**Reference: Ferrous Chloride Odor Control Station
City of Albuquerque EPC Project No. 1000896
Re-submittal**

To: Development Review Board
From: Makita Hill, Planner, Advance Planning Division MAH
Date: Tuesday, May 29, 2002
Re: Comments on Project 1000896/02DRB-00777

TITLE: FERROUS CHLORIDE ODOR CONTROL
STA NO. 28, GOFF BLVD.
SITE PLAN

55'-0" SEMITRAILER AND TRACTOR COMBINATION MIN. PRACTICAL TURNING RADIUS OF 50'-0"

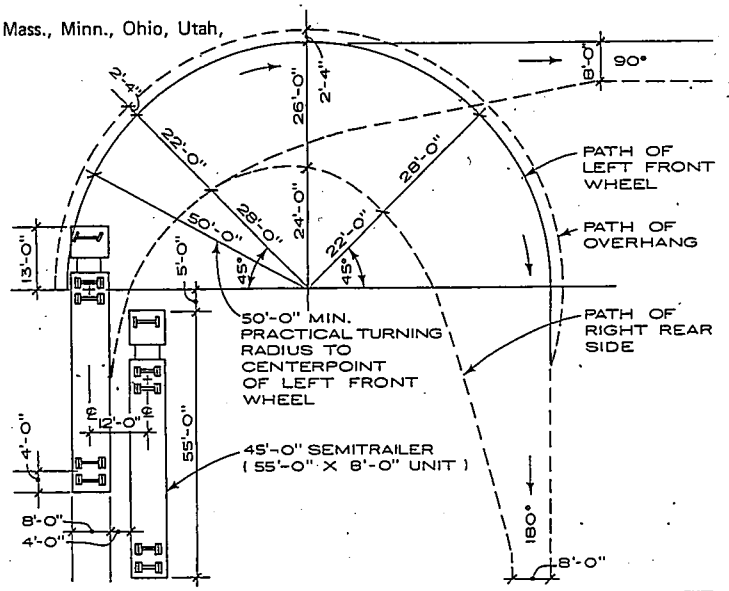
No.	Comment
<input type="checkbox"/>	More detail is needed for the entrance.
<input type="checkbox"/>	What type of maintenance vehicle is needed for this site?

1. Delivery of chemicals will be performed by tractor-trailers. The frequency of these deliveries is expected not to exceed once per month. Other activities at the site are limited to maintenance staff that use pick-up type trucks. This activity is expected not to exceed once per day.
2. Turning radiuses for a tractor-trailer are depicted on the Site Plan.
3. Due to required turning radiuses the tractor-trailers will have to back in and upon leaving go south.

HDR HDR Engineering, Inc.	Date 06/03/02
	Figure 1

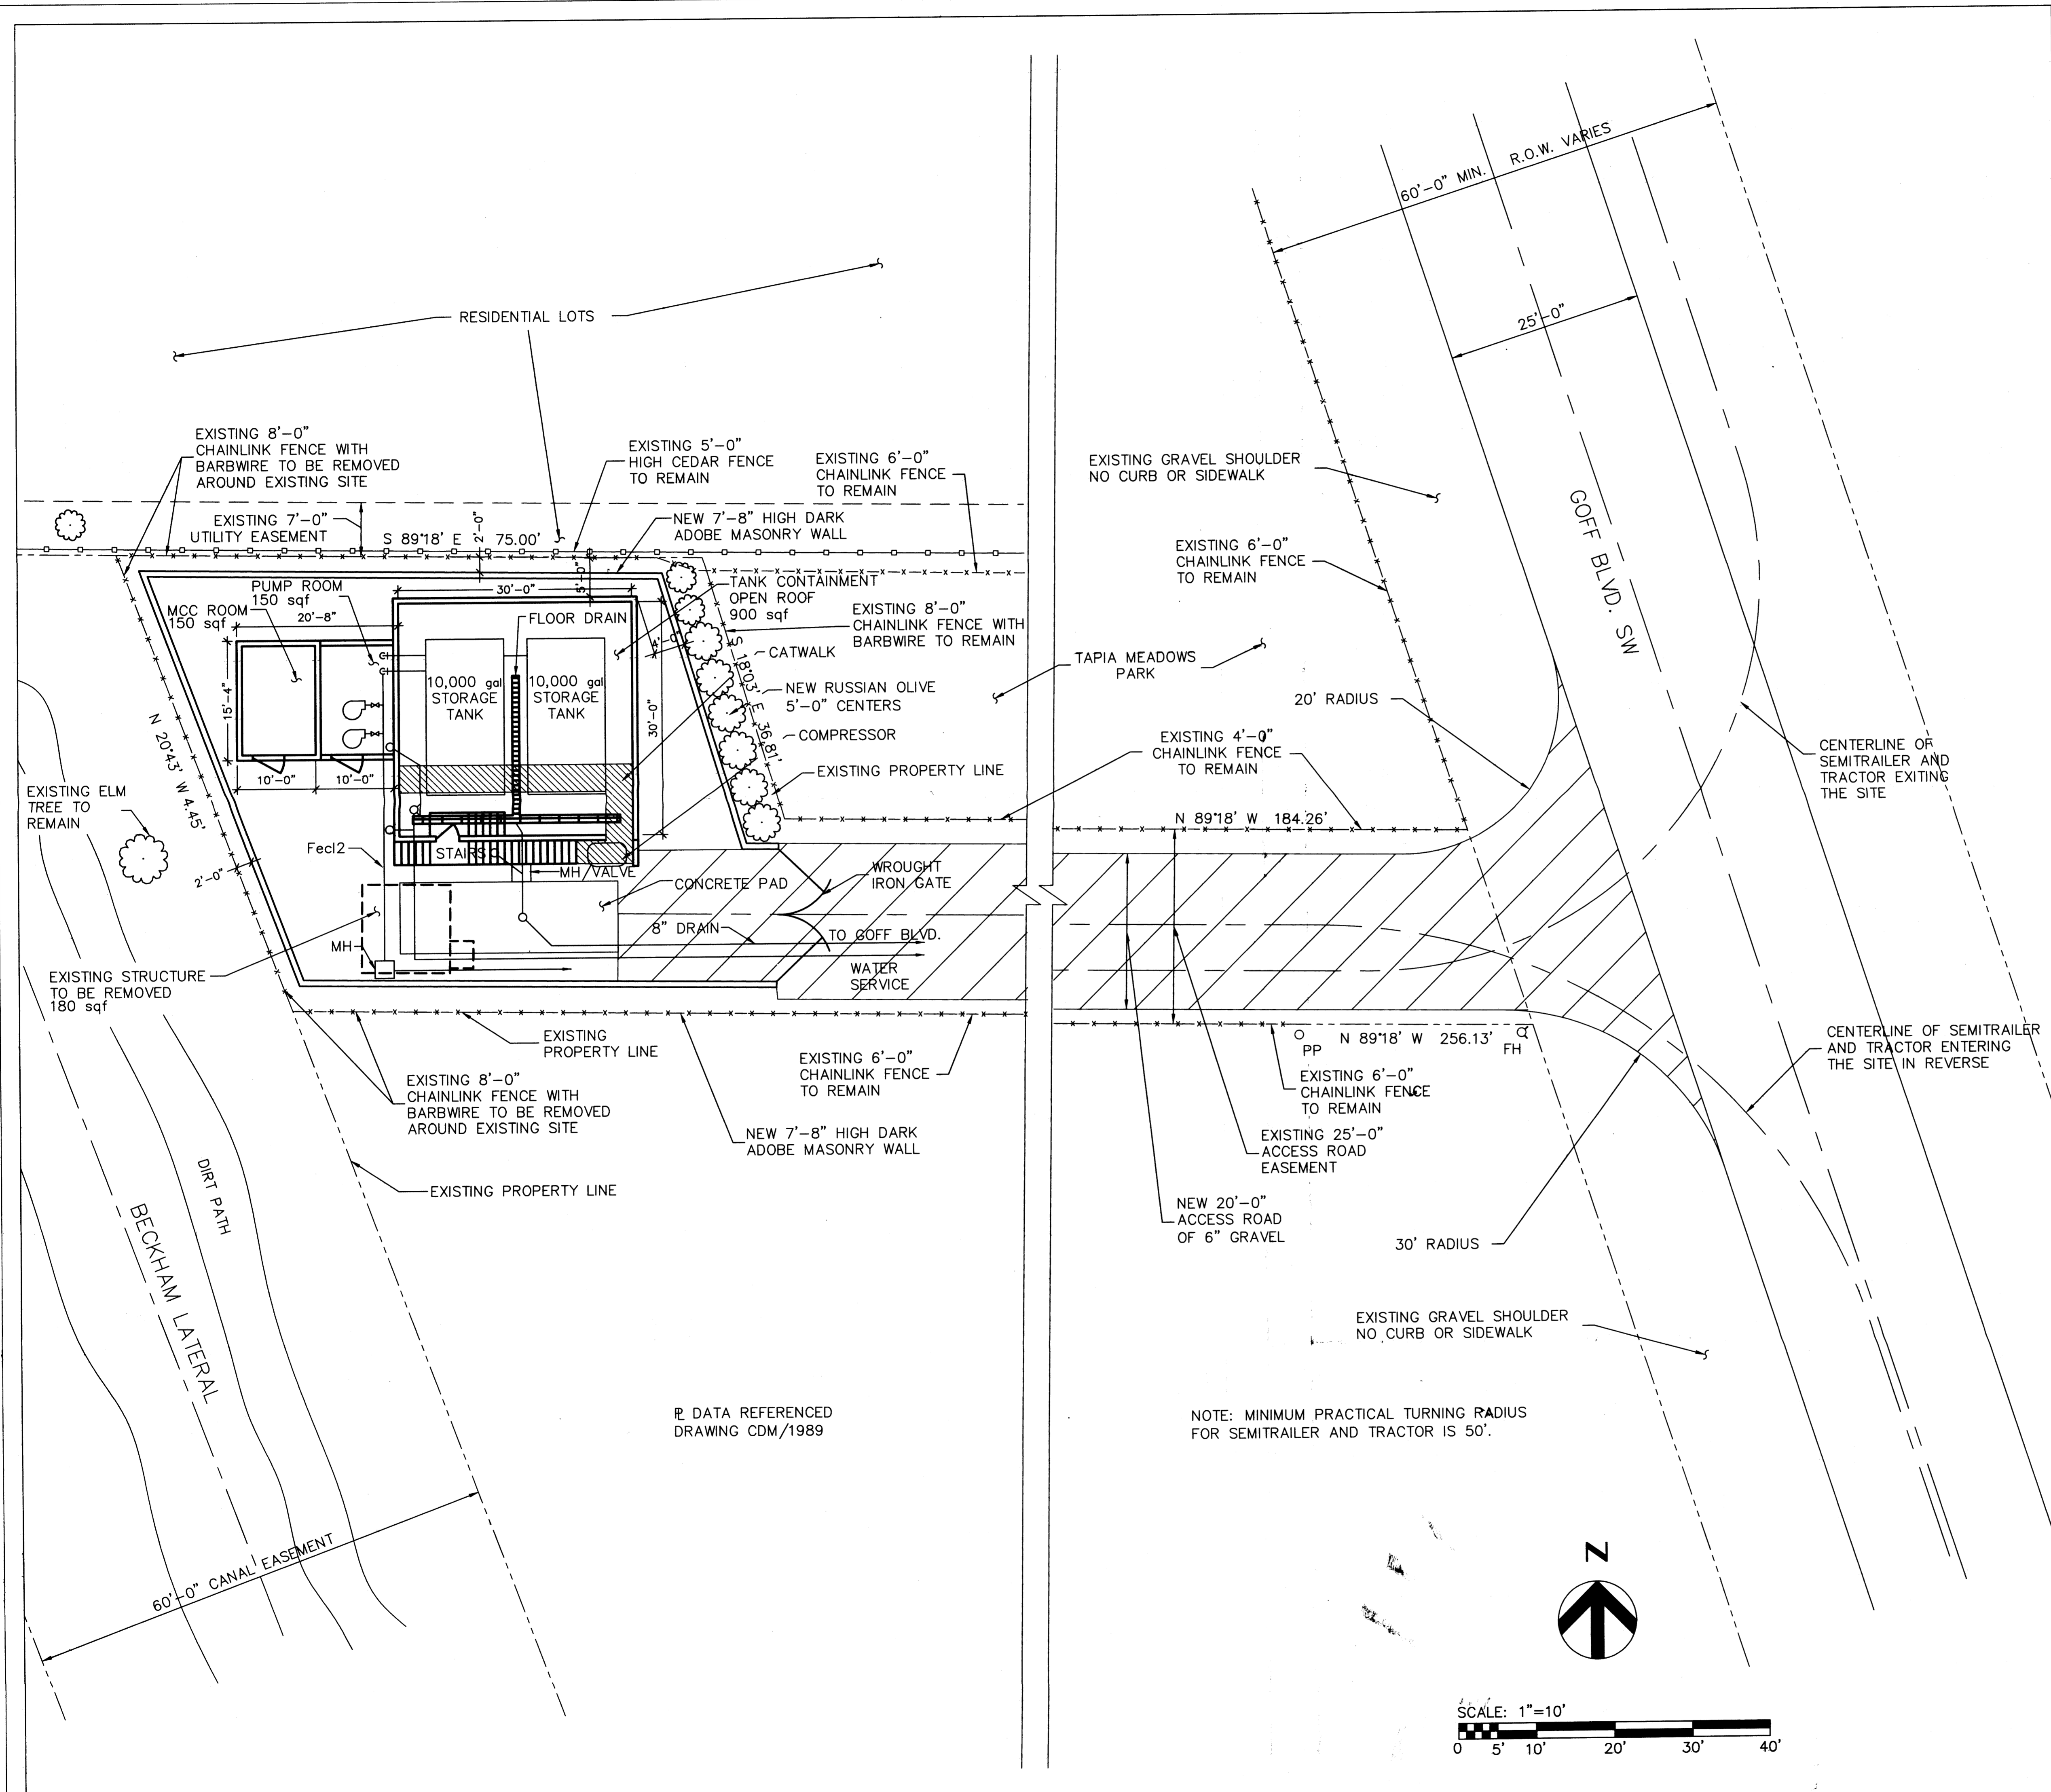
6. Chain link fencing adjacent to the public park is undesirable and should be minimized.
7. No direct access exists between the existing dirt path and lateral to the park.
8. Landscaping is not adequately shown on the plan and large areas of the site indicate no surface material. Under landscaping after the word "north" landscaping shall be a mixed of deciduous trees, evergreens and ground covers reaching a 75% canopy at maturity. Tree canopies are not included in that calculation. All areas that are not designated as shall be covered with landscaping which is not currently shown on the plan.

7. Provide an unrestricted minimum 5 foot access from the lateral to the park at either the north or south side of the building.
8. There shall be no chain link fence. New fencing shall be wrought iron and shall comply with the City of Albuquerque adopted wall and fence guidelines.

- A note was added to the site plan stating: "All site lighting, free-standing and building-mounted, shall be shielded with full cut-off fixtures mounted no higher than sixteen feet."

- The additional landscape buffer has not been added. The north side of the property was not added due to the utility easement and due to the lack of visibility because of the walls that the residential properties and the site has. The landscaping was not added to the west lateral due to the added wall next to the lateral and because of the all ready existing elm tree located on the Middle Rio Grande Conservancy District (MRGCD) property.

- A note has been added stating: "Noise produced by outside engines on site shall be mitigated to meet the city noise ordinance."
- The fence on the eastside of the building was not moved flush with the building due to the change of the fence to a wall. This was acceptable due to the letters from the City Safety Manager and a neighborhood association regarding the change of the fence to a block wall. Russell Britos, City Planning, supported this statement and felt that this was within his authority based on the wishes of the neighborhood association and the technical documents.

- The 5-foot access from the lateral to the park was not added due to the letters from the City Safety Manager and a neighborhood association stating that the access should not be installed. Russell Britos, City Planning, supported this statement and felt that this was within his authority based on the wishes of the neighborhood association and the technical documents.

- The chain link fence was changed to a dark adobe block wall instead of a wrought iron railing again due to the letters from the City Safety Manager and a neighborhood association stating that a block wall should be installed instead of the wrought iron railing. Russell Britos, City Planning, supported this statement and felt that this was within his authority based on the wishes of the neighborhood association and the technical documents.
